Dr Rivett Outline Response to Updated Statement of Common Ground and Jenny Lightfoot Proof of Evidence

Re: Appeal APP/M1900/W/21/3278097 (Nov. 2021) on rejection of proposed quarrying activity, Hatfield Aerodrome

What is the story on this monitoring point?

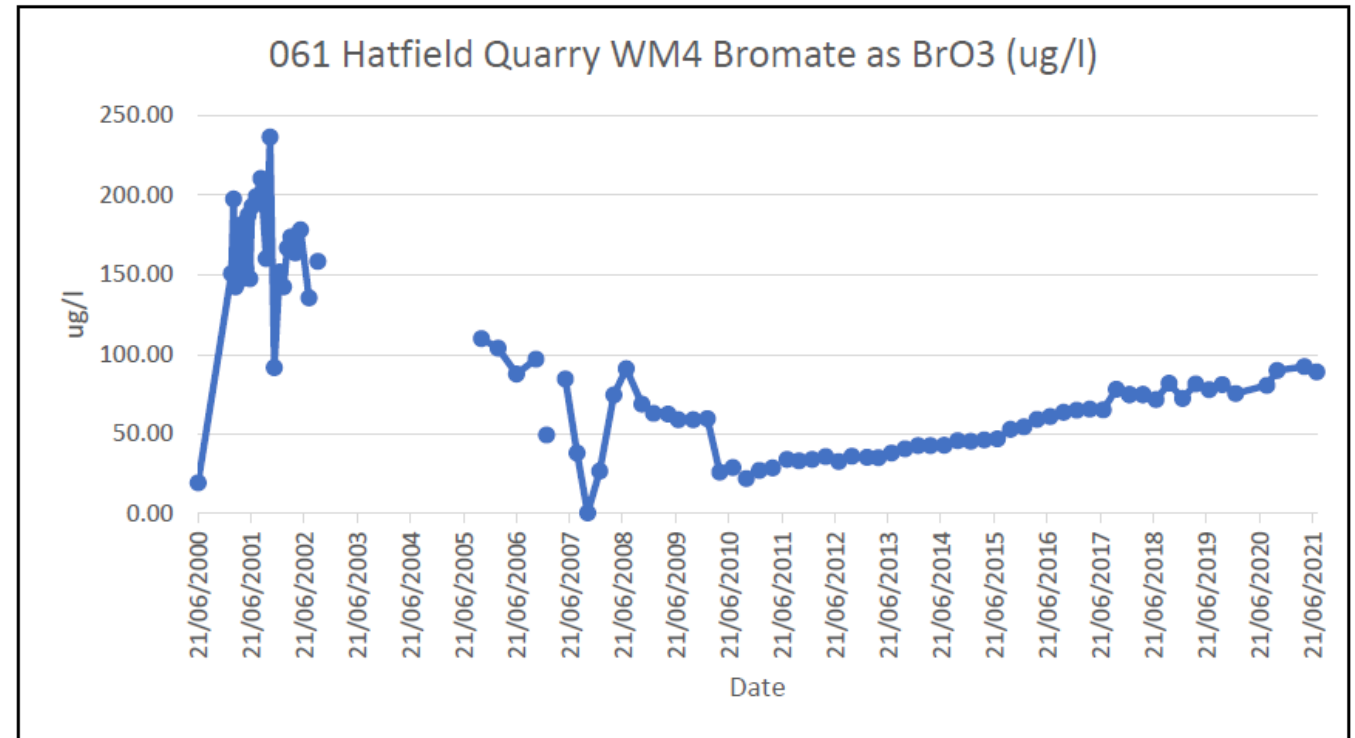
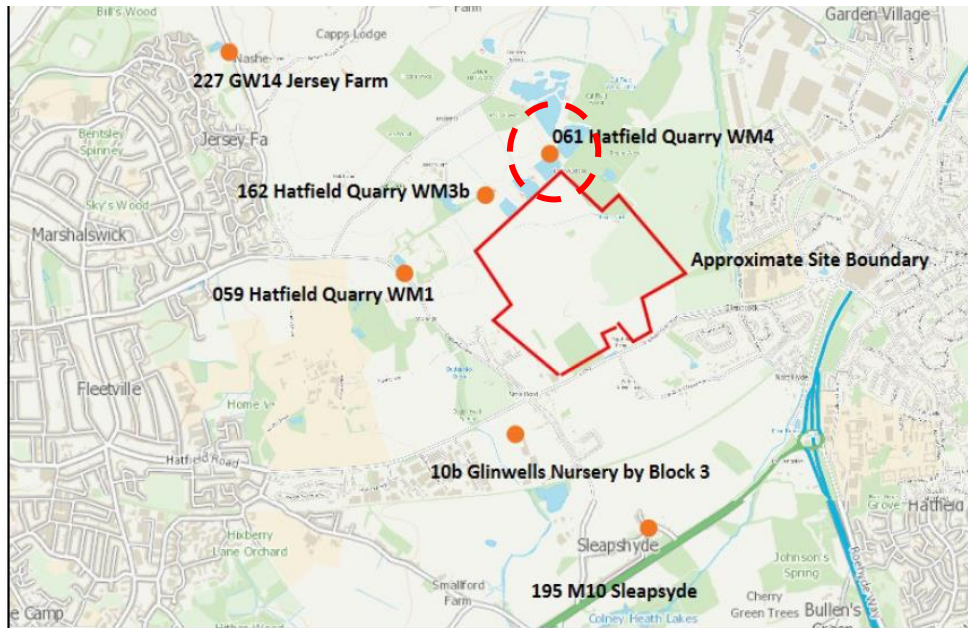
- It looks relevant?
- What is the course of these temporal variations?
- Control of HATF (high rates?) / Other abstractions?

33. Figure 3: Schematic cross section of the restored site¹ (SLR, 2015)

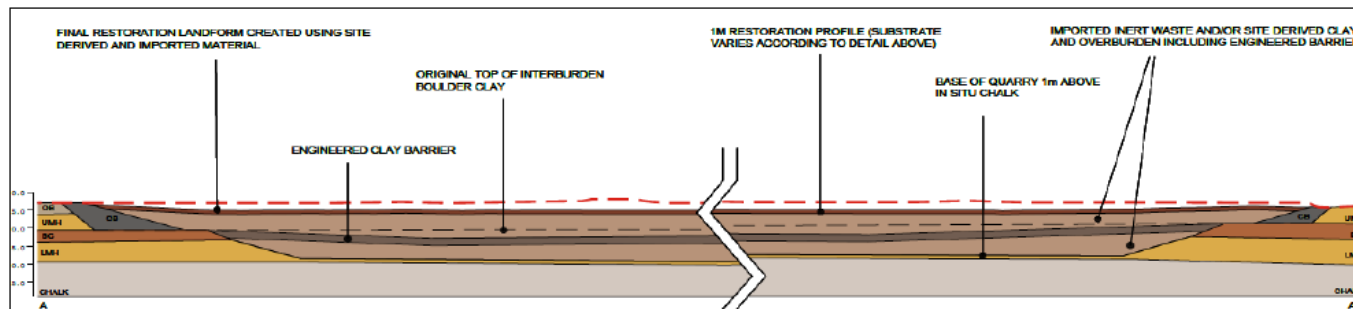
- Easier for groundwater to go around the side in the LMH?
- or to dive underneath in the sliver of LMH remaining / access the horizontal chalk fractures?
- or a bit of both?
- My expectation of the flowfield is that diverted flows would go north/eastwards pushing the bromate plume away from HATF to some extent

Backfill impact

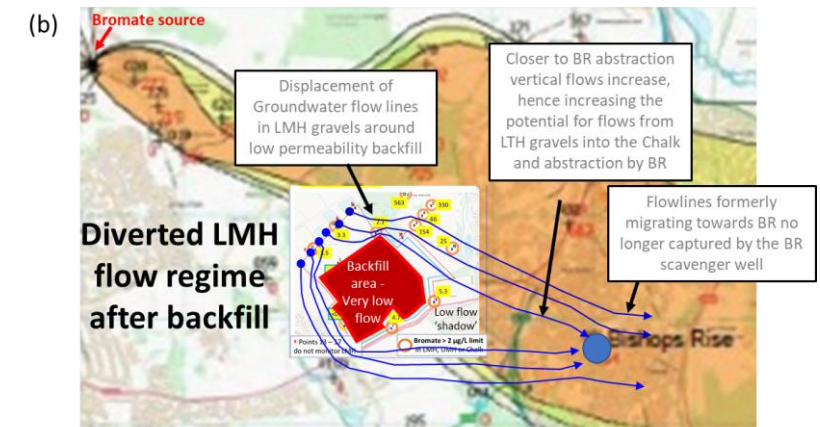
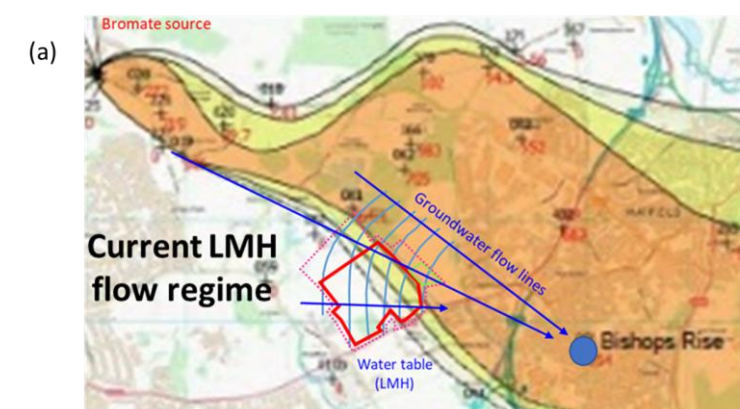
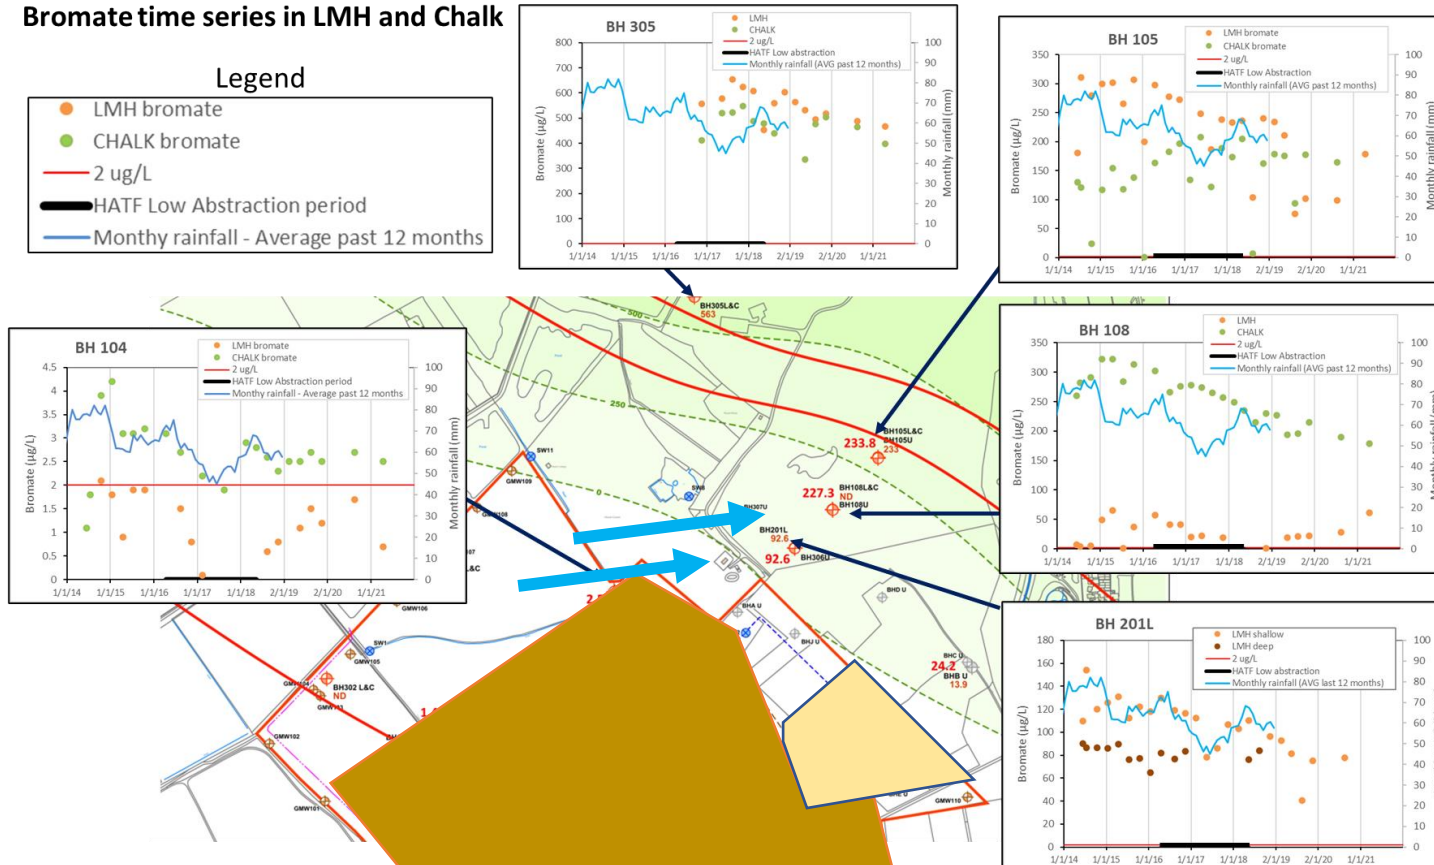
What bromate **will be** abstracted by HATF after low permeability backfill of the LMH?

- In short, not as much as before backfill as the LMH plume will be pushed away from HATF

Will increased bromate concentrations be seen in the local Site's boundary monitoring?

- NO – it would predict concentrations would decrease local to the Site, hence triggers looking for concentration increases would not be appropriate in this case
